NOTICE OF CHANGE

INCH-POUND
MIL-STD-202F
NOTICE 14
6 February 1998

TEST METHOD STANDARD
ELECTRONIC AND ELECTRICAL COMPONENT PARTS

METHOD 210E

FIGURE 210-1. Component lead and mounting examples.

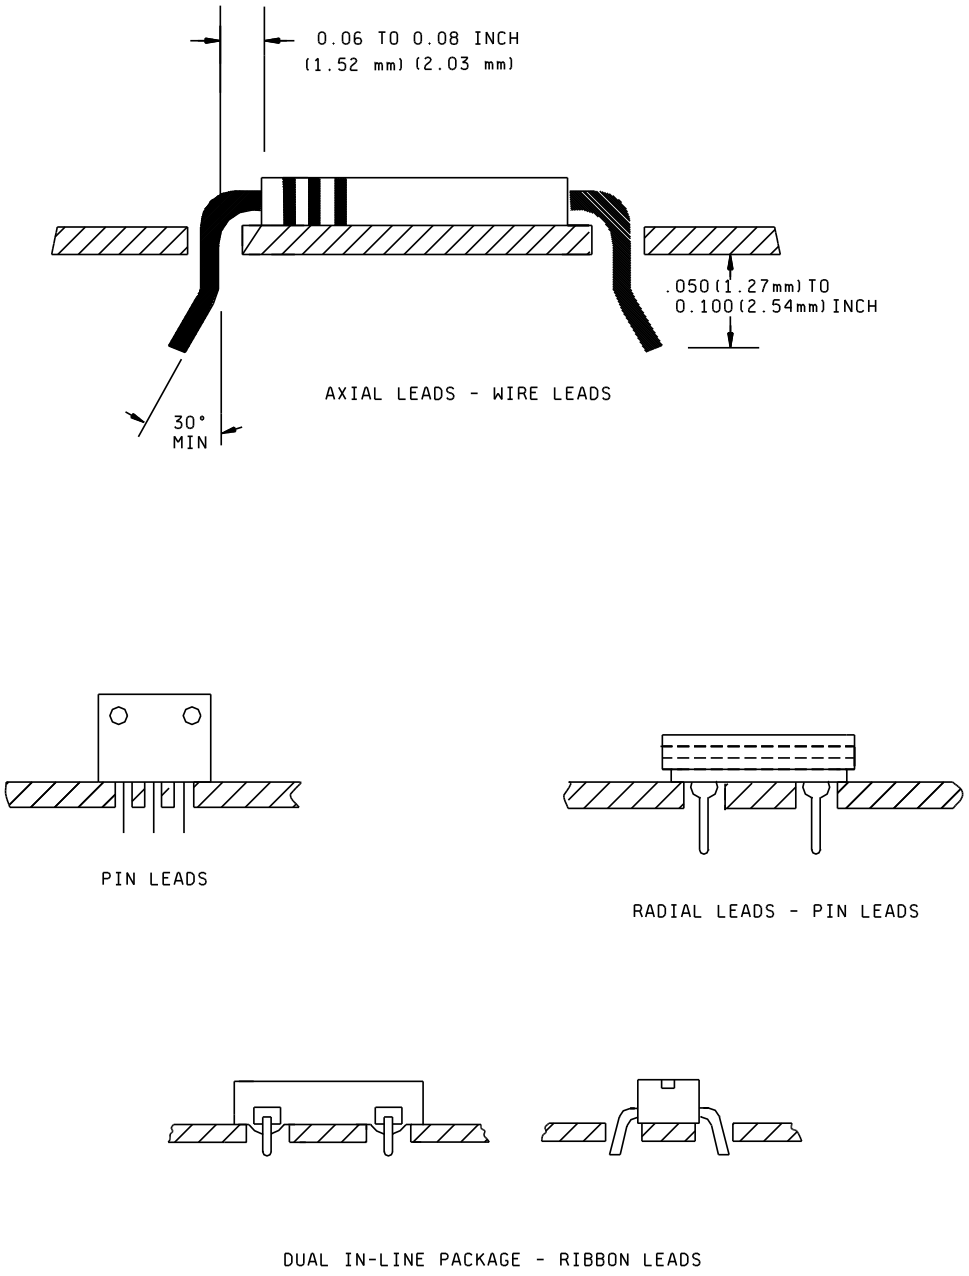
Wire leads: Wire leads shall be brought through the board holes and bent at least 30 degrees from a line perpendicular to the board. Leads shall extend from .050 inch to .100 inch (1.27 mm to 2.54 mm) from the bottom of the board. Axial leads shall be bent at a 90 degree angle at a point between .06 inch and .08 inch (1.5 mm and 2.1 mm) from the body, eyelet fillet or weld unless otherwise specified (see figure 210-1).

Pin leads: Where the component is designed with rigid pin leads, the full length of the termination shall be retained. Pin leads shall not be cut or bent (see figure 210-1).
